MEMORANDUM

DATE February 29, 2024 PROJECT # 18150C
TO Mark Parry PROJECT Ferry Building, San Francisco
Director of Construction
OF Hudson Pacific Properties FROM Peter Birkholz, Principal,
Page & Turnbull
CC Amanda Kost, Hudson Pacific VIA Email
Properties
Lada Kocherovsky, Page & Turnbull
Tara Ogle, Page & Turnbull

REGARDING Ferry Building – Secretary of the Interior’s Standards Compliance Analysis

Figure 2: Proposed glazing locations at entry portico. New glazed walls and doors identified with red arrows.

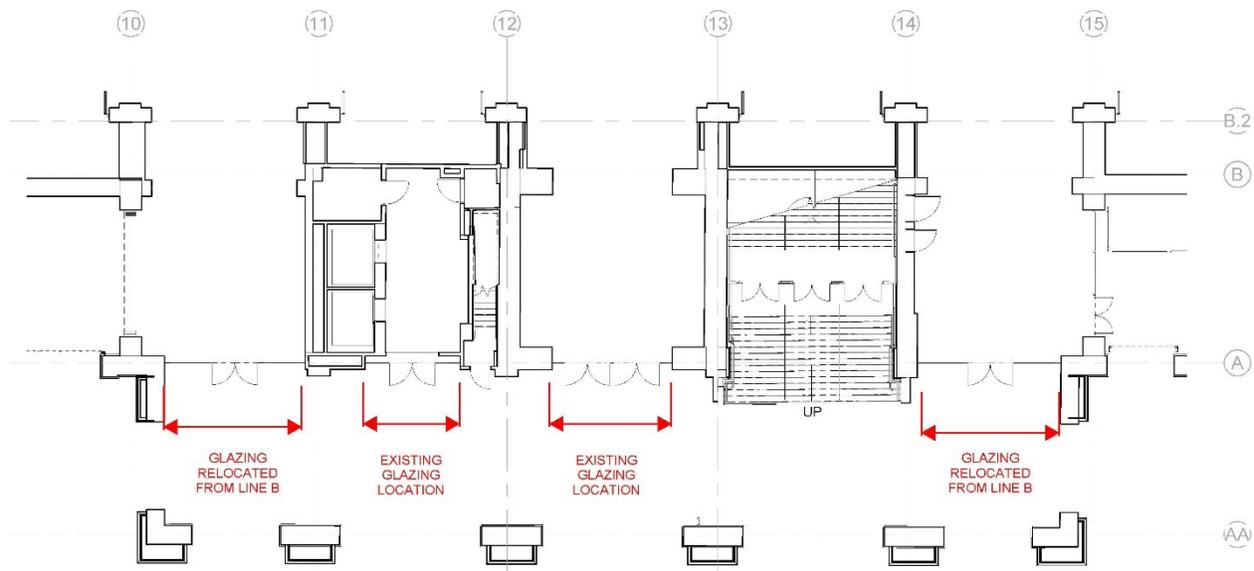
Within the entry portico, non-historic glass partitions and glazed doors are located at column line A within bay two (containing the elevator vestibule) and bay three (containing the central breezeway), and at column line B in bays one and five, which provide access to the ground-floor marketplace. A glazed wall with glazed doors is also located partway up the historic main stairs at bay four. These

non-historic partitions were installed during the 2003 Ferry Building rehabilitation project. As proposed, the glazing within bays one and five will be moved forward from their current location at column line B, to column line A. This will bring the glazing of these two outer bays in line with the existing glazing at the elevator vestibule and the central breezeway (**Figure 2**). These new glazed walls and entrance doors will be installed in a phased approach with bay one installed when work is undertaken at the north arcade, and bay five installed when the south arcade is enclosed at a future date (proposed work at the arcades is described immediately following).

At the entrance portico, the addition of glazed partitions and doors at the first and fifth bays along column line A will enclose two additional bays of the building, but are in keeping with the existing treatment of the other openings within the entrance portico. Moving the glazing forward, from column line B to A, is consistent with the glazing of bays two and three and will not impact the character, materials, or features of the entrance portico, which will continue to be the primary entrance to the Ferry Building,

Figure 3: Proposed glazing systems and enclosure at north open-air arcade of primary (west) façade.

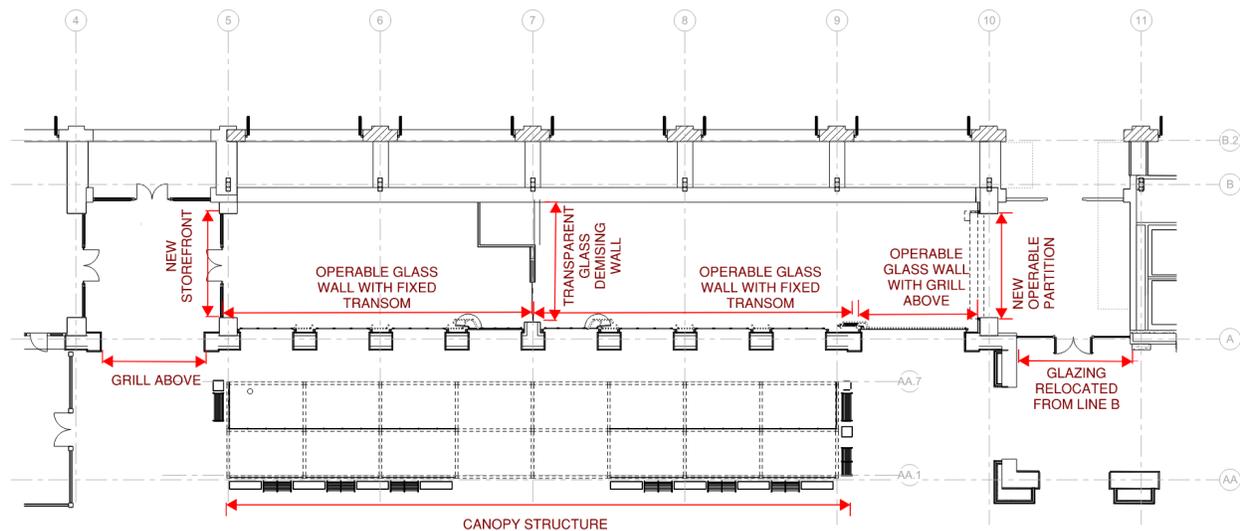
Each open-air arcade along the west façade of the building contains approximately 4,130 square feet that is currently used in a variety of configurations including storage, commercial units, and unprogrammed space. The project proposes to initially enclose the north arcade to create two or more additional commercial units. The south arcade is encumbered with a subtenant lease obligation so the enclosure of this space will commence after sublease expiration in 2027. The existing roll-down metal grille system that is mounted behind each opening of the arcade will be removed, and glass partitions, consisting of an operable glass wall system with fixed transoms within the arched openings above, will be installed behind the openings to the arcades at their west wall from column line 5 to 9 and 15 to 20 (**Figure 3**). The larger rectangular opening between column line 9 and 10 will have a similar operable glass wall system that will be full height to the bottom of a fixed grille supplying air intake to the interior space. This operable glass wall system will be hidden

behind each column when fully opened and retracted. The large rectilinear openings between column lines 4 and 5 at the north arcade and column lines 20 and 21 at the south arcade will be left open to the exterior and will contain mechanical vents with decorative grilles at the top portion of their openings to provide required fresh air and exhaust for the spaces within the arcades. These necessary vents with decorative grilles will replace the rolling overhead doors and decorative grilles that were installed as part of the 2003 renovation. A glazed wall with glazed doors will be installed at the north end of the arcade at column line 5 and a glazed operable partition at column line 10 to allow the arcades to be closed and secured. This pattern will be replicated and reflected in the south arcade at column lines 15 and 21 as a future phase.

Within the arcades, one or more demising walls will physically separate the various commercial units. The forward portion of the demising wall (closest to the Embarcadero) will be both transparent and operable. This will allow each commercial area to be secured when necessary, while also ensuring that each arcade remains a single volume with views and movement along the length of the space.

The alterations currently proposed for the arcades will minorly alter the existing open-air arcades along the primary façade, features that are considered of primary significance to the character of the building (refer to Significance Diagrams, attached as **Appendix A**). As described within the attached Significance Diagrams, areas and features of primary significance are those which date from the building's original construction in 1898 through repairs completed in 1906; these features and materials are the most historically significant components of the building. While interventions in the form of glazing will infill the openings of the north and south arcades, the proposed wall system is transparent, mounted along the interior of the arched opening, and operable with fixed transoms, allowing the wall system to be retracted and hidden behind each pier. As the glazing systems will be substantially transparent and operable, the arcades will be able to remain open to the air, which is a key characteristic of the historic building.

To provide for restaurant cooking requirements, fresh air intake and exhaust vents with decorative painted grilles are proposed, these vents are located at the upper portion of the rectilinear openings at the north arcade (column lines 4 to 5 and 9 to 10) are set back from the primary plane of the façade to ensure that the historic fabric of the façade and the character of the arcade is retained. Due to the proposed setback, the ventilation grilles will be visually deferential to the proportions and size of the overall opening and will not impact the viewers ability to visually read the arcades as a series of regular and repeating openings. This treatment will be repeated at the south arcade in the future.
